Subject: RE: January 24 Plan Commission meeting info re: University Research Park–Pioneer 1st Addition Replat

University Research Park responses to John Horn Comments:

UNIVERSITY RESEARCH PARK
UNIVERSITY RESEARCH PARK -2
PIONEER 1ST ADDITION

DRAINAGE TO HAWK'S LANDING
SWALE

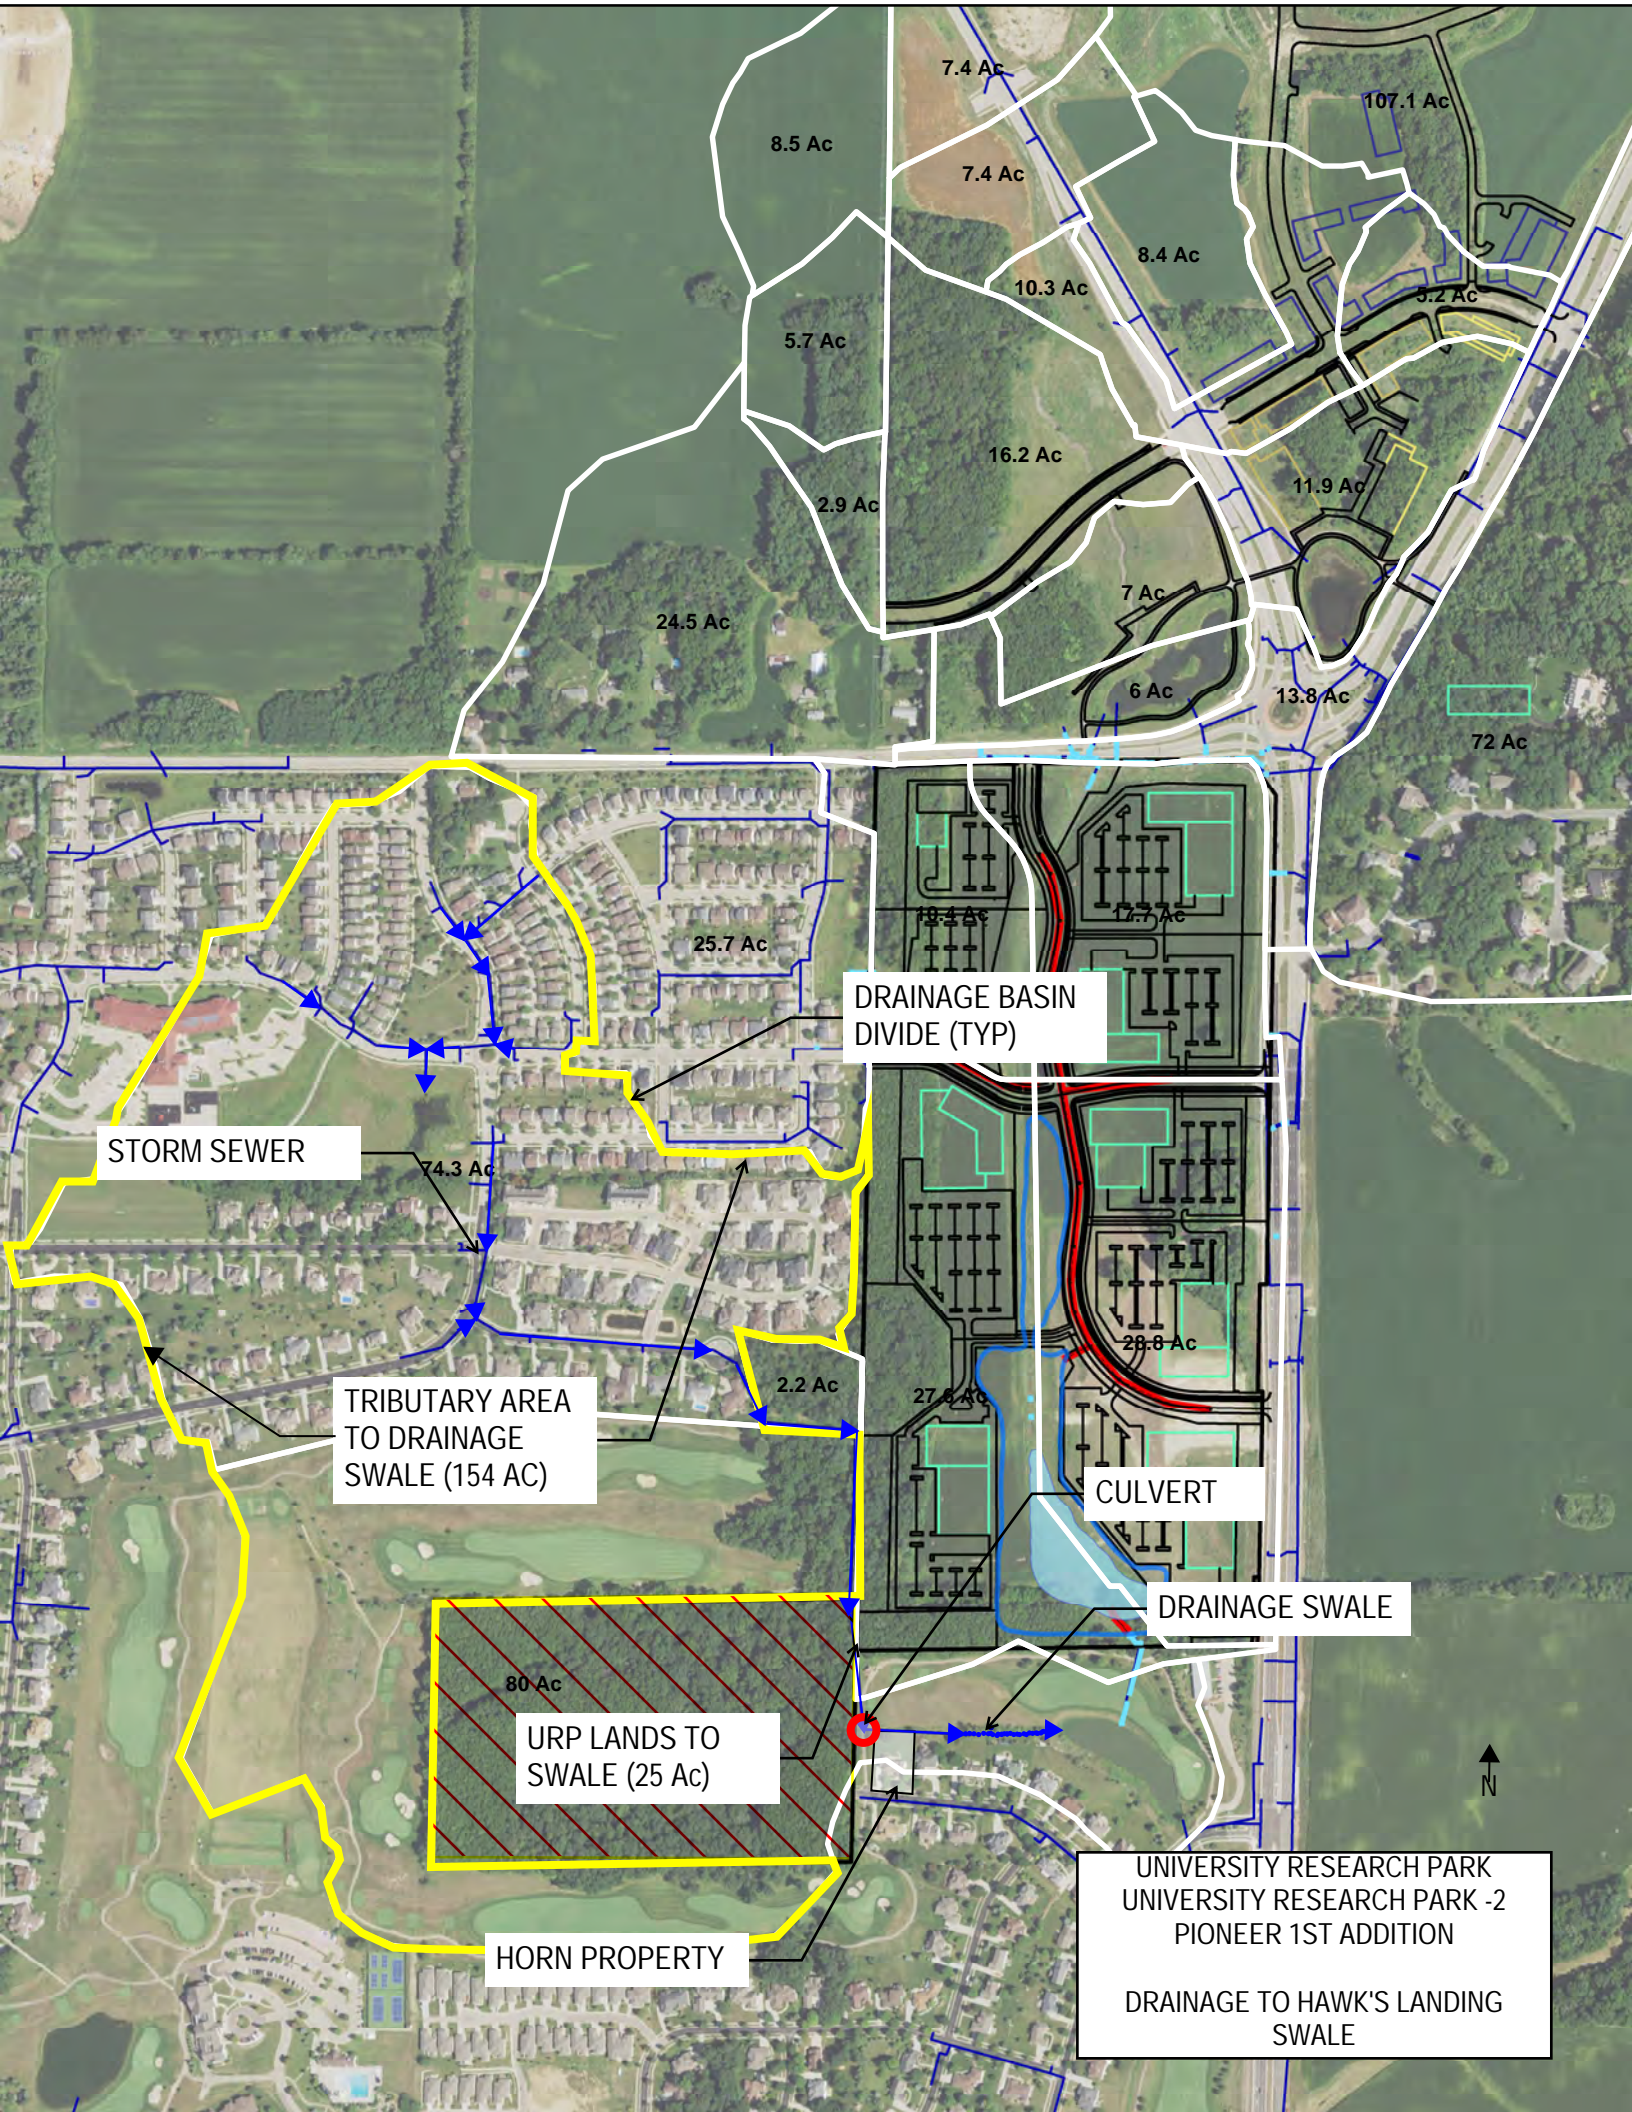
With respect to Mr. Horn's comments/concerns on drainage from the 25-acre parcel west of his property:

3. Mr. Horn is incorrect in his contention that the primary source of runoff to the swale is from the 25-acre woodlands. While the woods are a primary source of runoff onto the Horn property during small storm events, because the land hasn't been extensively disturbed since the Hawk's Landing subdivision was constructed, this volume presumably would have been the "natural condition" at the time of Hawk's infrastructure design. This should have been accounted for when the swale was originally designed. As indicated on the attached drawing, the primary source of excess runoff to the swale during large storm events is the storm sewer draining from the north connected to the culvert and swale. This storm sewer drains approximately a 129-acre portion of fully developed land (in addition to the 25-acre parcel owned by URP). During these large events, excess stormwater runoff from this storm sewer likely overflows the cart path and onto the Horn property when the culvert capacity is exceeded.

4. URP does not have the legal authority to implement the drainage improvements requested by Mr. Horn. URP does not own the storm sewer that is the source of the majority of runoff to the swale or the culvert under the cart path near the 25-acre woods.
